Proposed Revisions to a Design Standards Index

Index Number: 600 Date: July 3, 2017

Index Title: General Information for Traffic Control Through Phone: (850) 414-4314

Summary of the changes: Sheet 1: Changed Preface to General Notes. Deleted MUTCD statement. Deleted Symbols. Updated Table of Contents. Sheet 3: Added minimum radius for 70 mph. Clarified Note 1 of "Length of Lane Closures". Sheet 5: Updated Notes. Sheet 9: Changed warning to channelizing. Deleted "Warning Device Notes" and table. Deleted bicyclist from "Pedestrian and/or Bicyclist Way Drop-off Condition Notes". Sheet 11: Added "Temporary Barrier Notes". Sheet 12: Deleted "Temporary Substitution of RPMs for Paint or Removable Tape". Changed retroreflective to raised for RPMs. Updated notes.

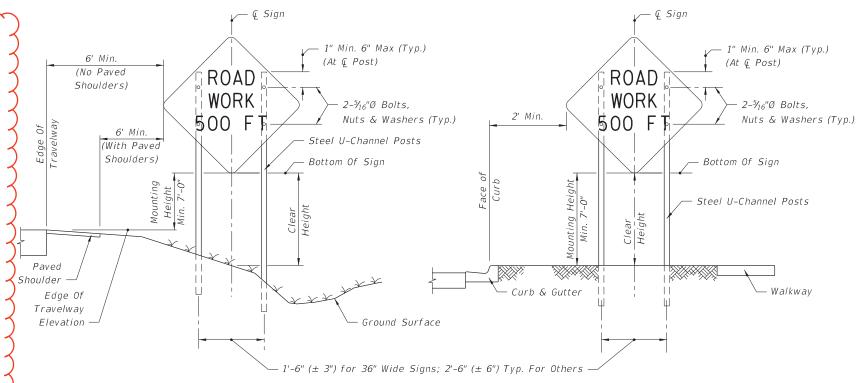
> Changed to **GENERAL NOTES**

IDENTIFICATIONS - CHANNELIZING DEVICES

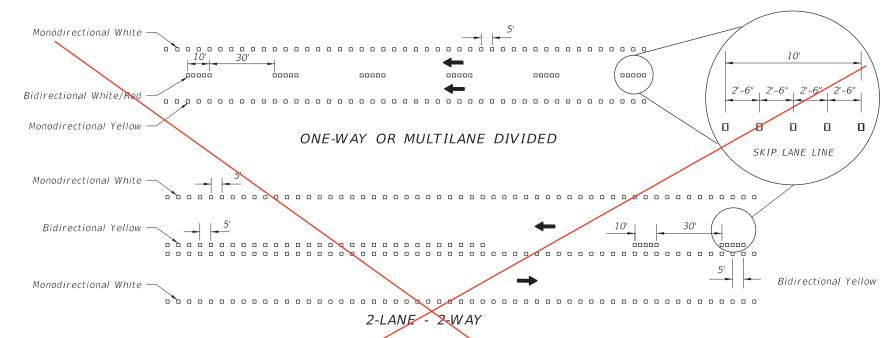
Changed to (8") to 8" to 12" (Typ.)

Added TEMPORARY BARRIER NOTES

PLACEMENT OF PAVEMENT MARKINGS

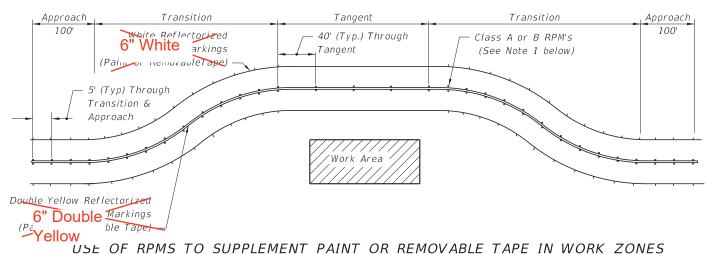
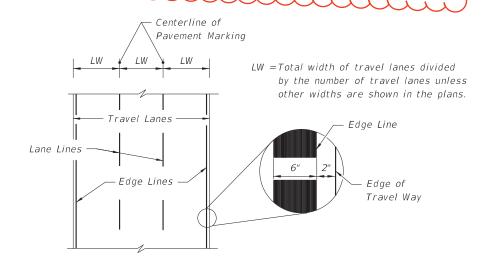
- |Deleted all To provide contrast on concrete followed by five black RPM's. THApostrophes from not be required for contrast wit RPMs and
- 3. RPM's used to supplement lane (Temporary), EA. RPM's used as | "Retroreflective to weather restrictions are to be p "Raised" and RPM's used as a temporary subs malfunction are to be placed at updated Notes
